SOUTH DOWNS NATIONAL PARK AUTHORITY

SDNPA Consultation Response

Draft Response

1. The South Downs National Park Authority (SDNPA) notes that Highways England (HE) is consulting on a single option only for the M3 Junction 9 scheme. The proposal (option 14) is to provide free flowing road links between the M3 and the A34 both northbound and southbound. The new road connections will pass each other and the existing M3 via a combination of flyovers and underpasses. New embankments, cuttings and retaining walls will be required to achieve this.

M3 Junction 9
Option 14 Proposal
South Downs Tranquility

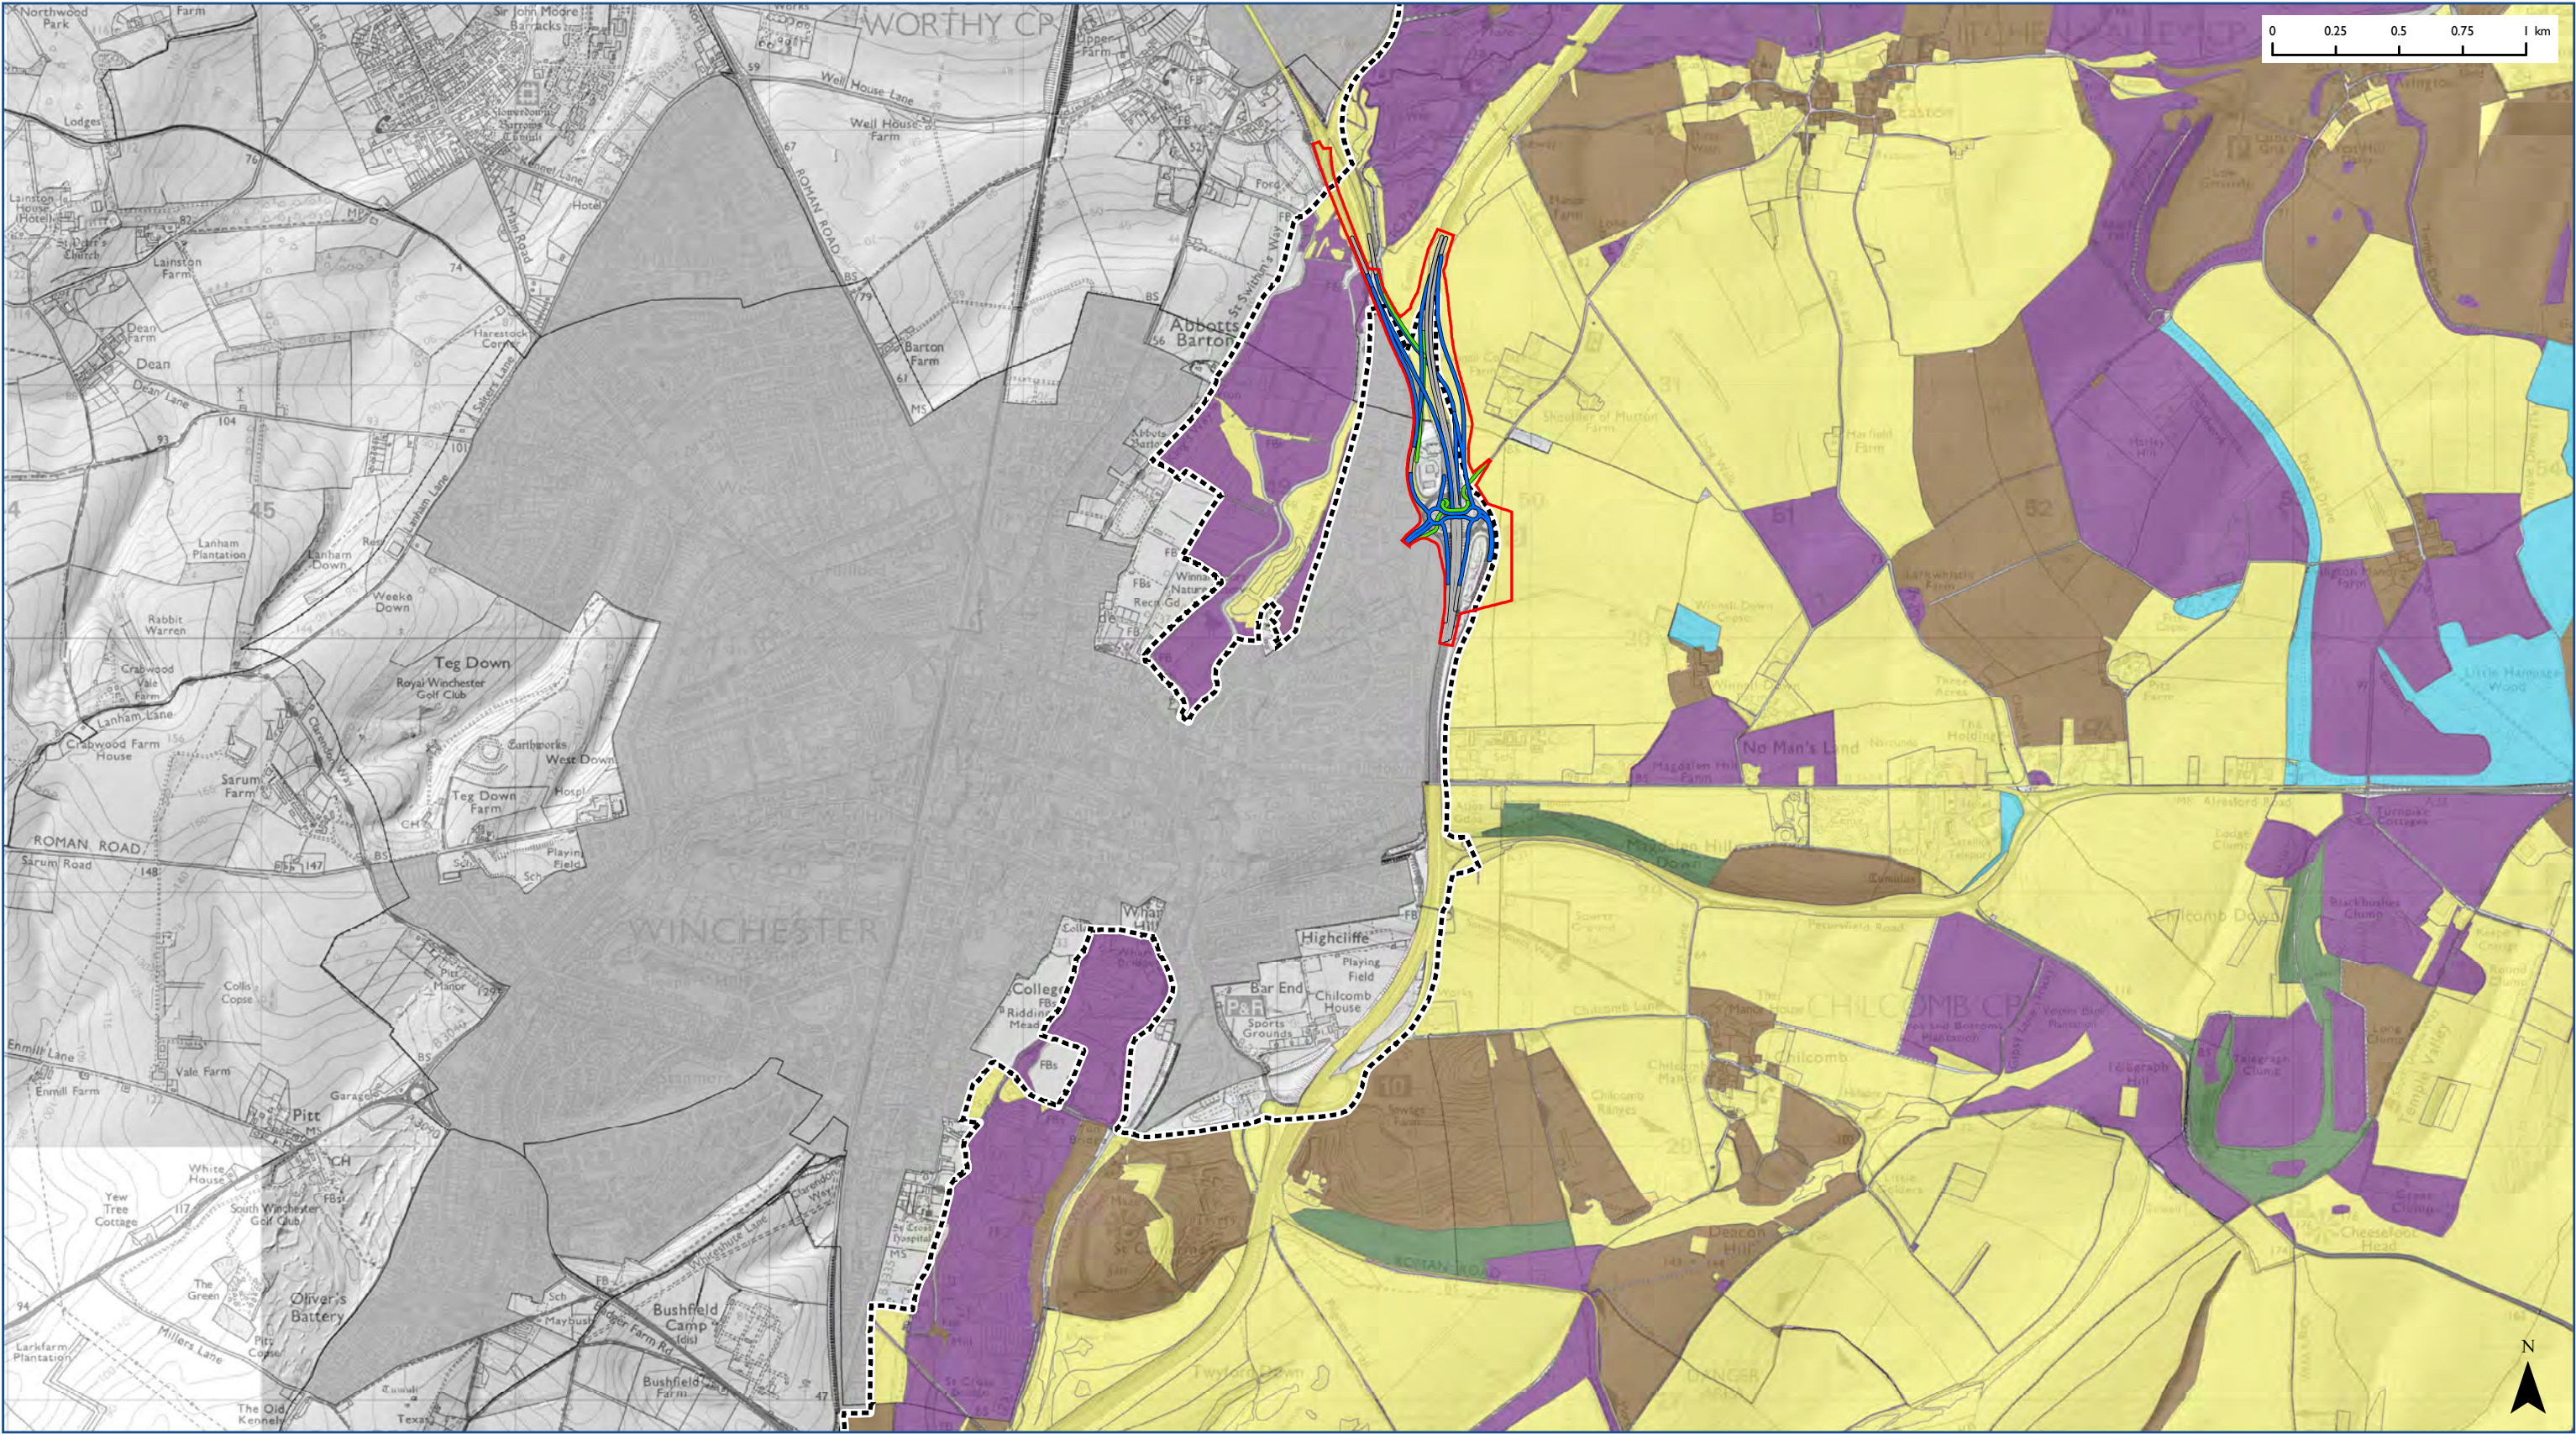
- 7.11. The site assessment considered five locations that would be affected by the extent of construction, two directly on the road corridor, two more areas immediately adjoining and one that considered more distant impacts (See figure ix Tranquillity Map).
